ADDENDUM NO. 4

Public Paving, Drainage, Water, Sanitary Sewer, Street
Light & Traffic Signal
Improvements

Intermodal Parkway BNSF to Old FM 156

CITY PROJECT NO.: 103332

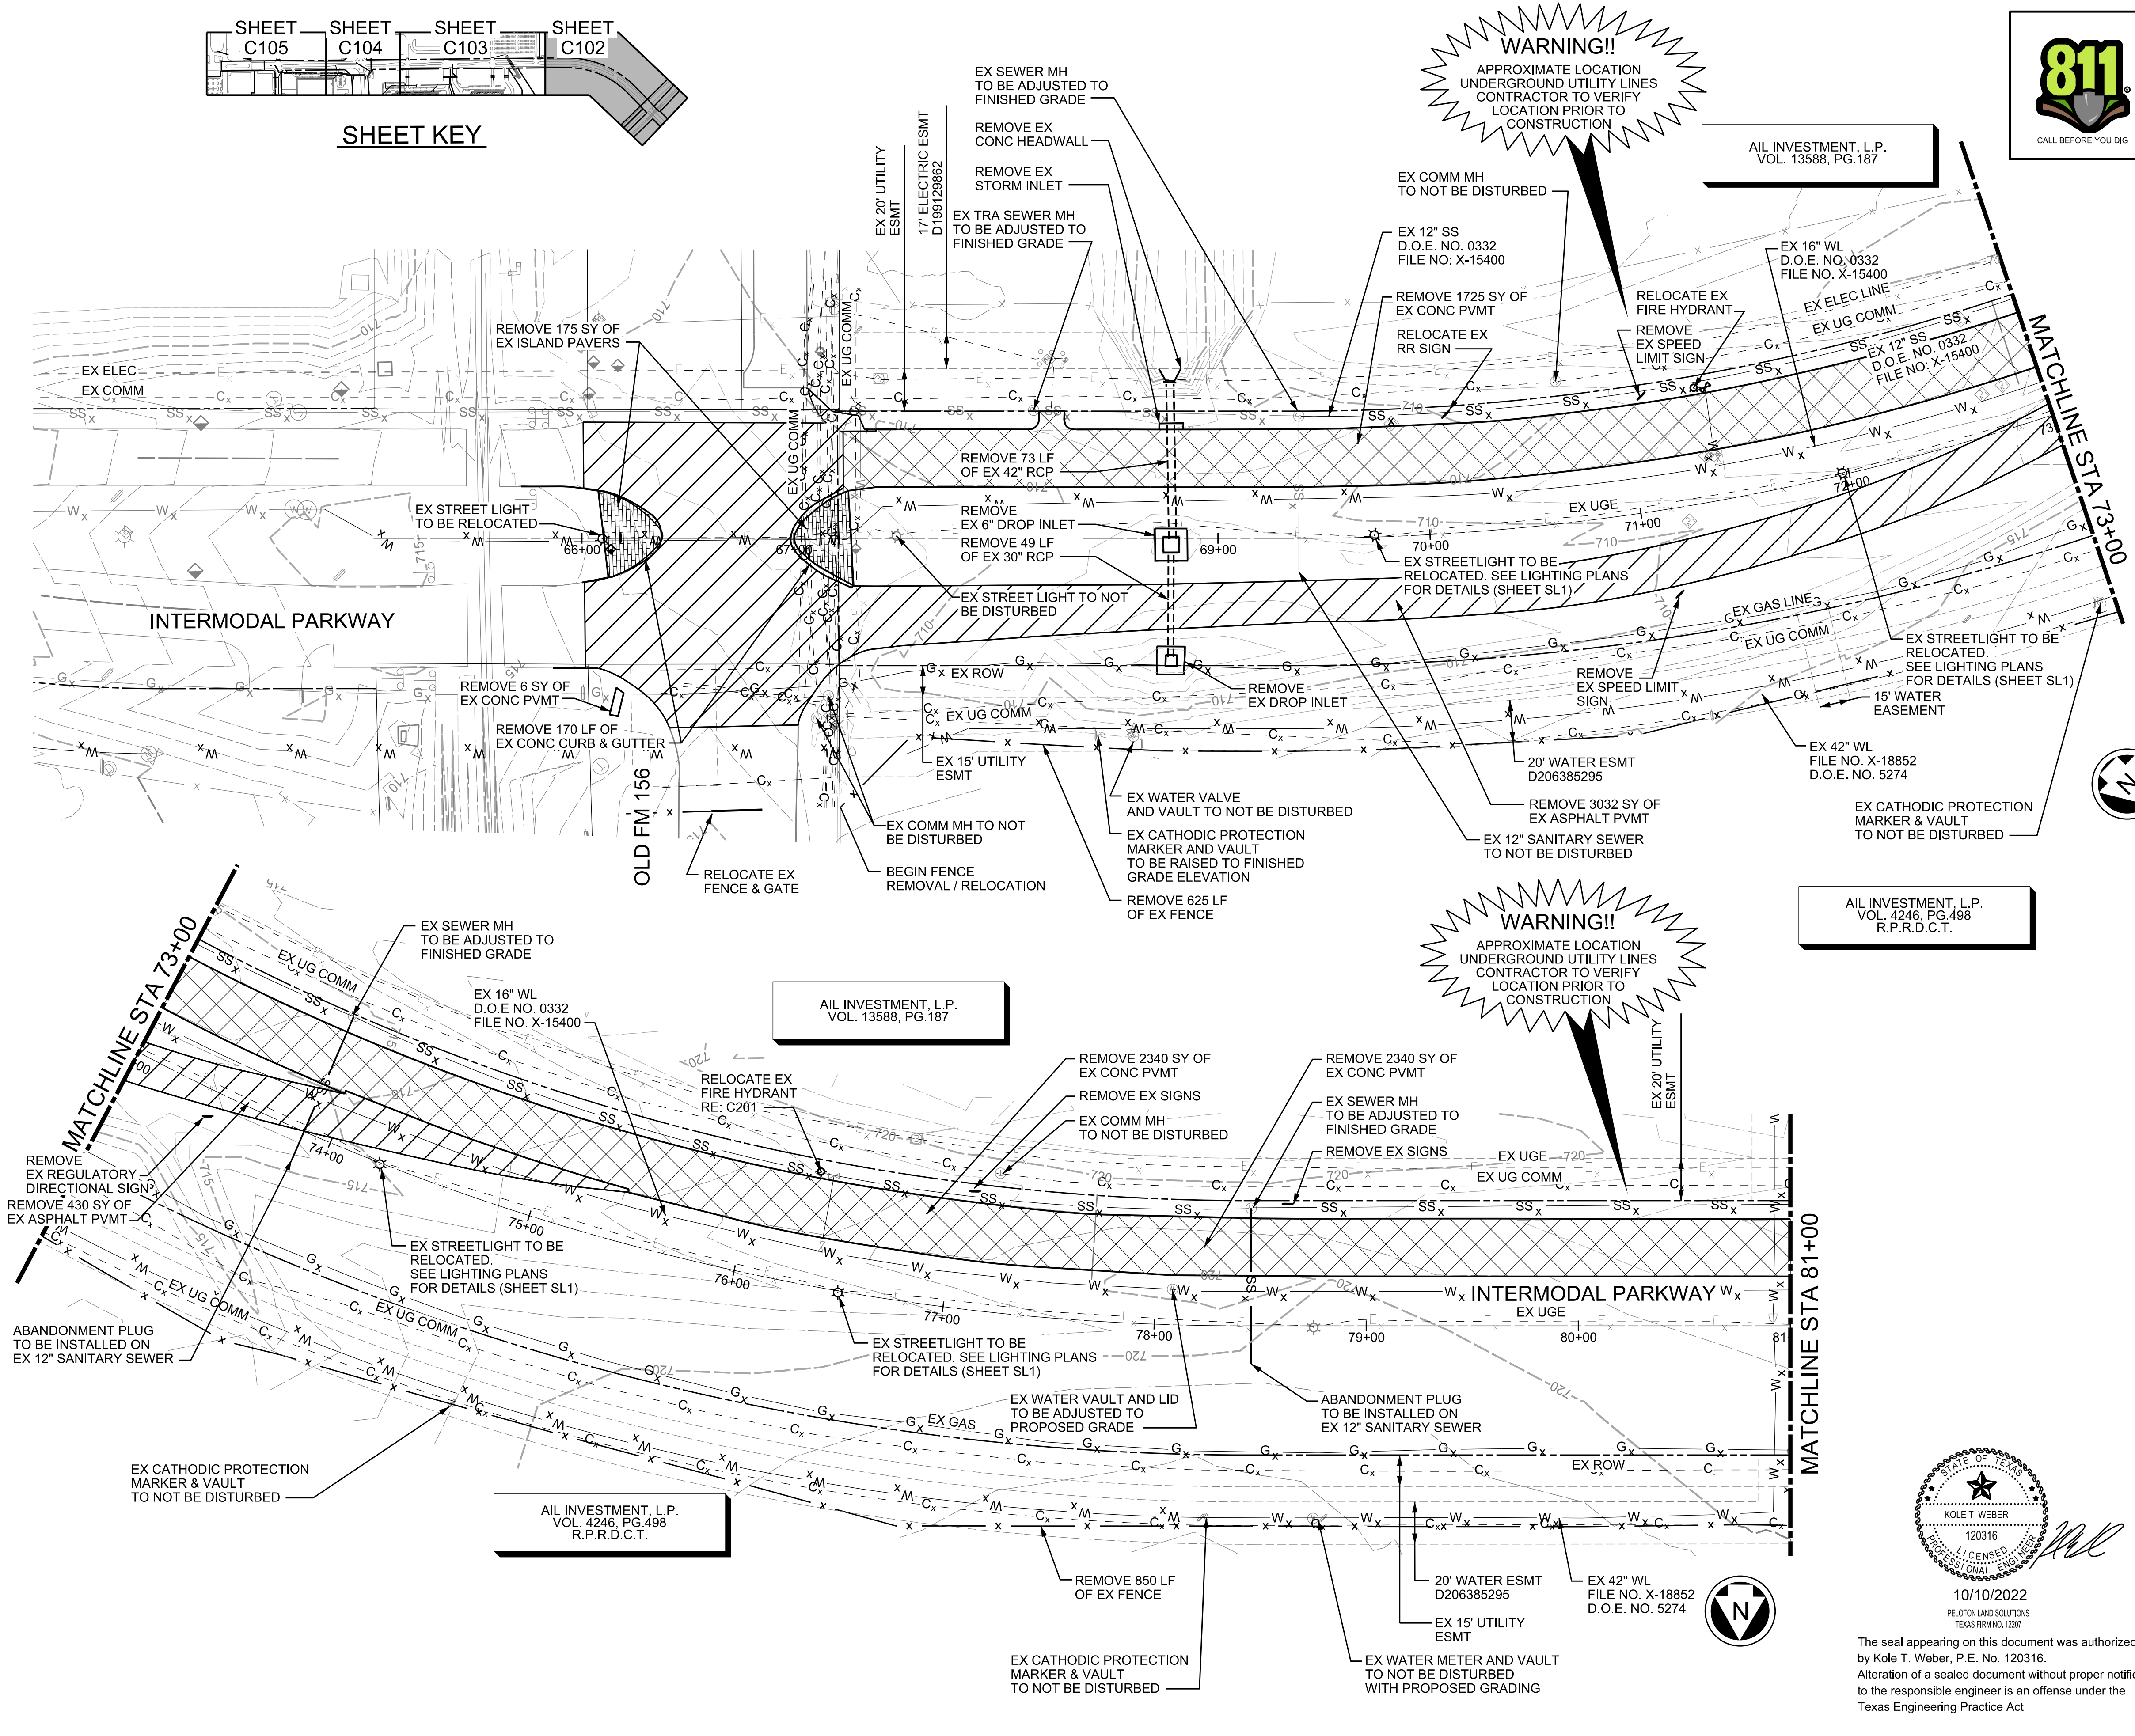
1. General: There appears to be a lot of blue and white signs with business names and entrance locations up and down the project. A lot of the signs are not called out on the plans. Are these signs to be relocated by the contractor? If so, are you anticipating overrunning the pay item quantities for this work?

Description of Change: The "Remove Sign" and "Relocate Sign" bid items have been updated. Also, plan sheets C102 through C105 have been updated to better reflect what type of sign is being removed or relocated.
